CITY OF TUCKER

ITB 2024-010

TUCKER TOWN GREEN CONSTRUCTION

ITB 2024-010
ADDENDUM #2

L2.01

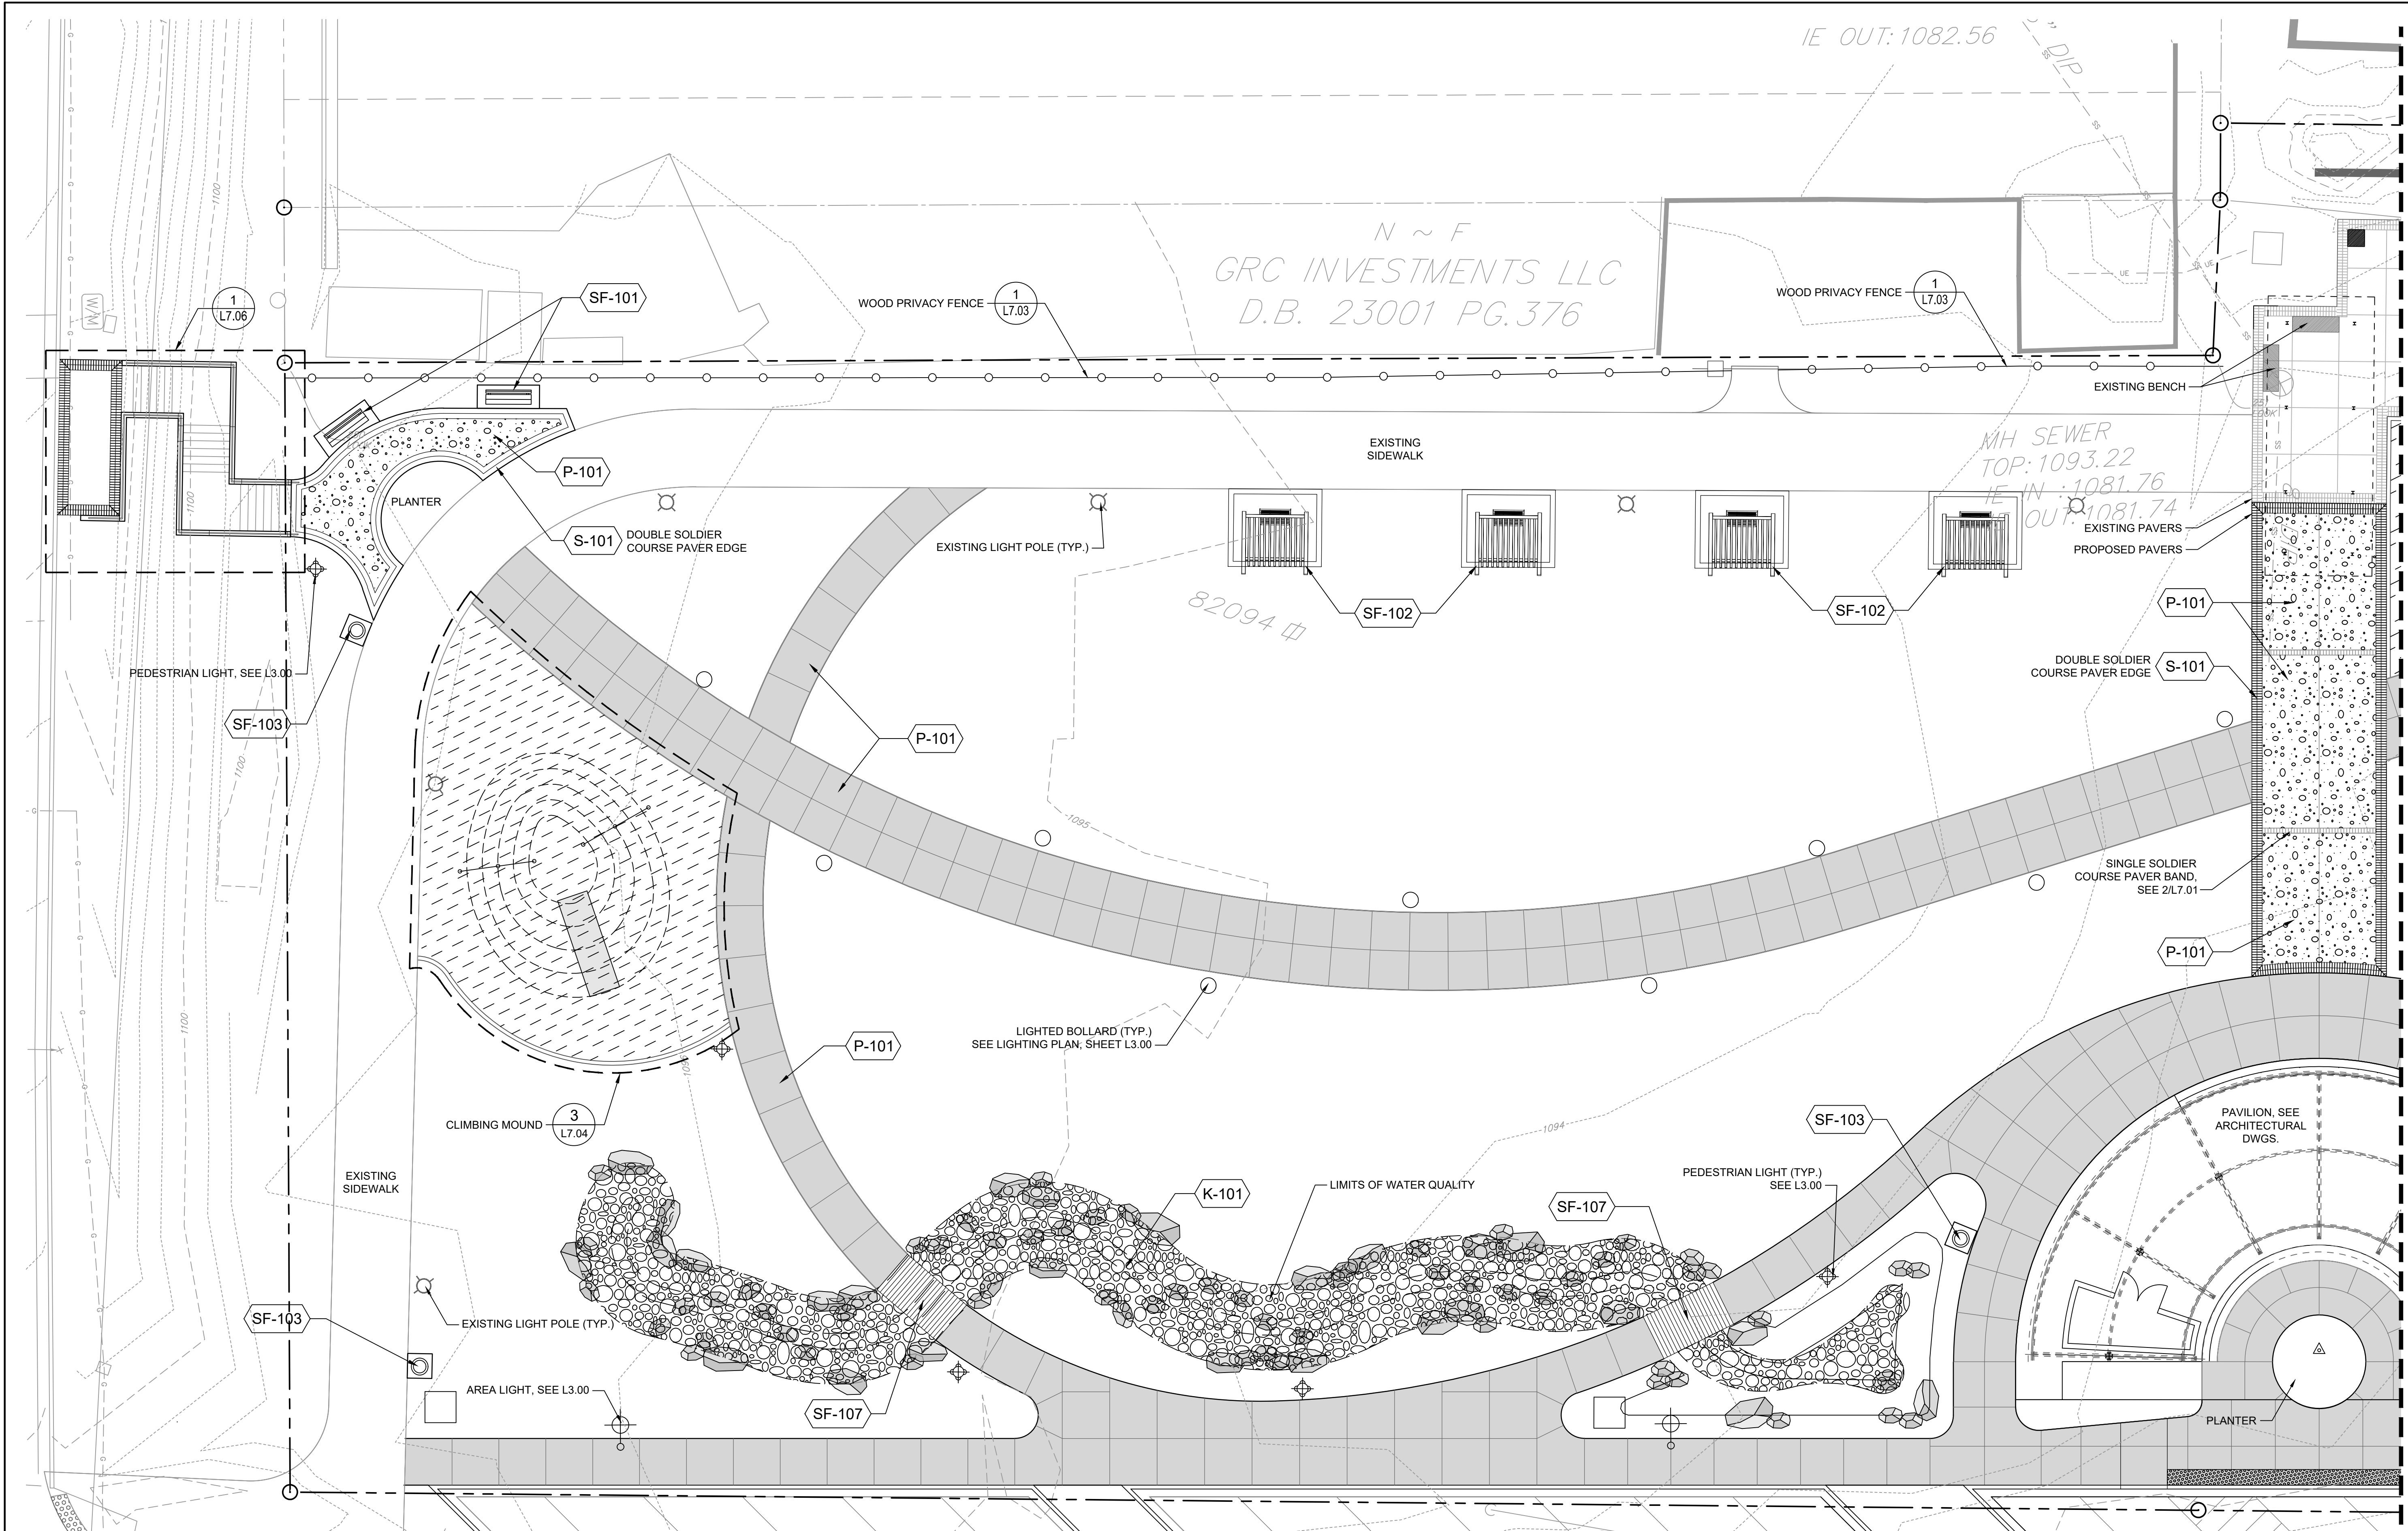
be included in our scope of work? If so, what are its details?	
13	On sheet L2.01, there are two (2) different hatched areas labeled P-101. What are the correct areas for the light duty concrete finish and the correct areas for the light duty exposed aggregate finish?	Sheet L-2.01 & L2.02 have been revised see attachment within this addendum to address incorrect labels.
14	The match lines do not match up on any of the sheets. Can you provide an updated set of plans?	Match lines seem to be in the correct locations, but will work with the awarded bidder prior to construction to make sure.
15	It is unclear where the Brick Paver Band (2/L7.01) ends on the top right section of sheet L2.02. Could you clarify the limits of new construction?	Sheet L-2.01 & L2.02 have been revised see attachment within this addendum. Brick Paver Band should stop at existing path.
16	Under the Paving Materials schedule on plan sheet L7.00, it lists a line item titled "Top-Cast concrete pavement" but this is not on the plans. Also, with its detail not showing the complete page number but only 1/701. Where can we get more information on this item and its details?	Top Cast Concrete Detail – 1 / L7.01 Pavement reference on Sheet L2.01 and L2.02 is < P-102> (See hatch key at bottom of sheet)

L2.02

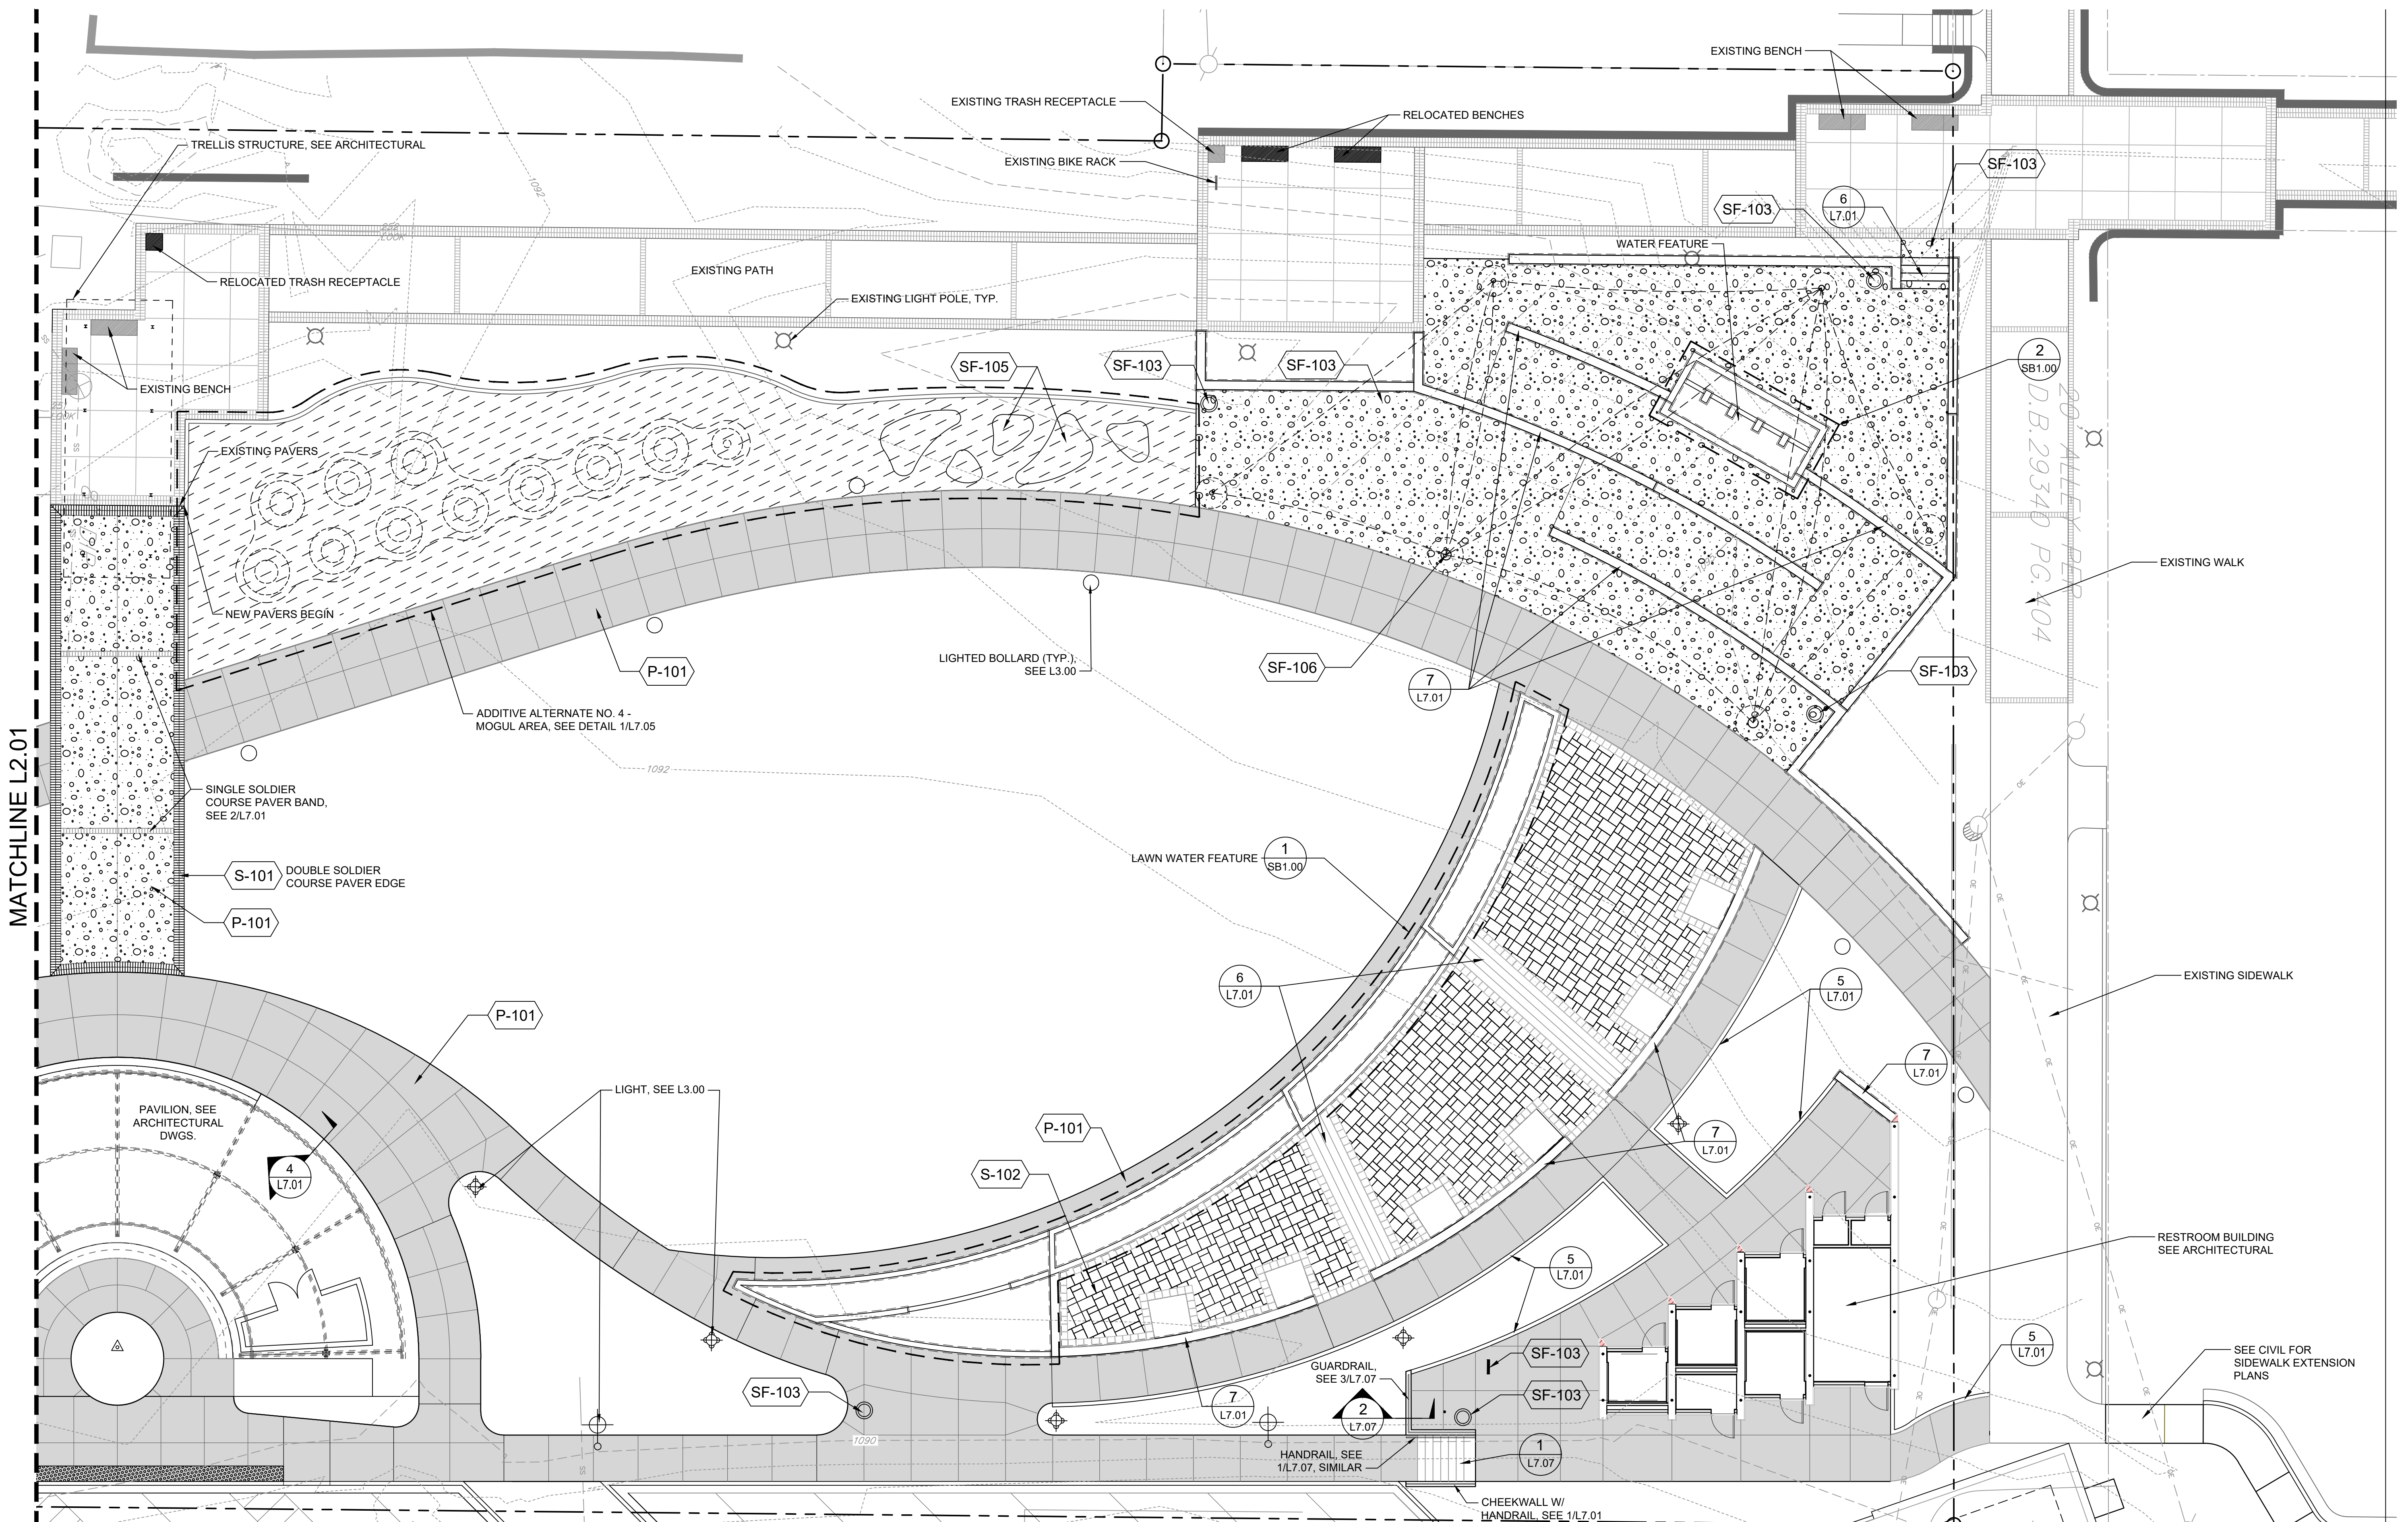
17	Please provide details on the following questions. 1. Park Monument details.	1. Park Monument sign has been removed from the project. No details necessary.
18	2. Synthetic Turf under the concrete benches . - Will we be placing the turf under the concrete benches, or do we need to cut around them on L2.02? Please Provide more details on the Mounds and any alternate(Foam Mounds) are acceptable.	Concrete benches shall be placed on top of the synthetic turf. Mounds. See Detail – 3/L7.06 for mounding information.
19	What are the details for SF-105 shown on plan sheet L2.02?	There are no SF-105 Site Furnishings included in this project. Sheet L-2.01 & L2.02 have been revised see attachment within this addendum and callout has been revised to SF-108.
20	Detail #3 shown on plan sheet L7.04 has the perimeter of the climbing mound area as fall safety zone and outside its perimeter it shows it as Synthetic turf play area. However, the	The entire area is to be synthetic turf. Detail #3 Sheet L7.04 has been revised to add a 1" thick pad 6'x6'. Fall safety zone is an offset area (Min 6'-0") around all play equipment in which no hard fall surfaces are to be located.
